1 **I. REMARKS**

1 **II. DRAWINGS**

Fig 4A

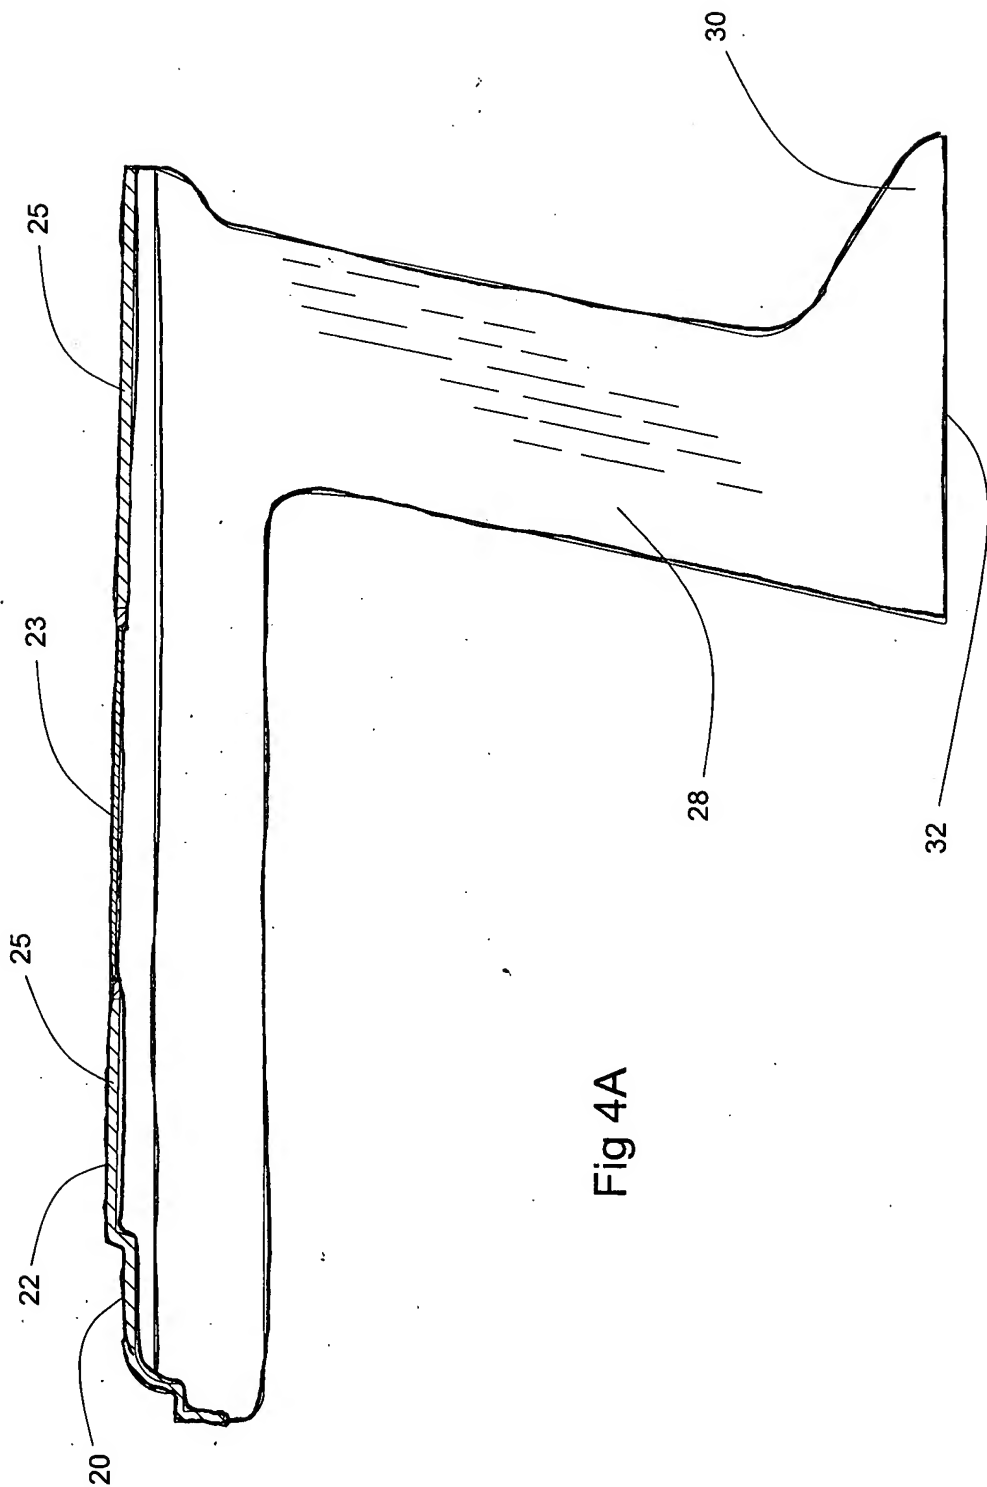
2
3 The Examiner has objected the drawings under 37 CFR 1.83(a) for not
4 showing every feature of the invention specified in the claims. Applicant
5 respectfully submits new figure 4, and figure 4a for the Examiner's
6 consideration.
7

8 Applicant respectfully directs the Examiner to note that new figure 4a
9 shows the filler material of claims 5 and 9. In addition, Applicant directs
10 the Examiner to note that the Specification of the above referenced patent
11 application has been amended to reflect amended figure 4 and new figure
12 4a as is described in Section III. below, and that no new matter has been
13 introduced.
14
15
16
17
18
19
20
21
22
23
24
25
26
27
28
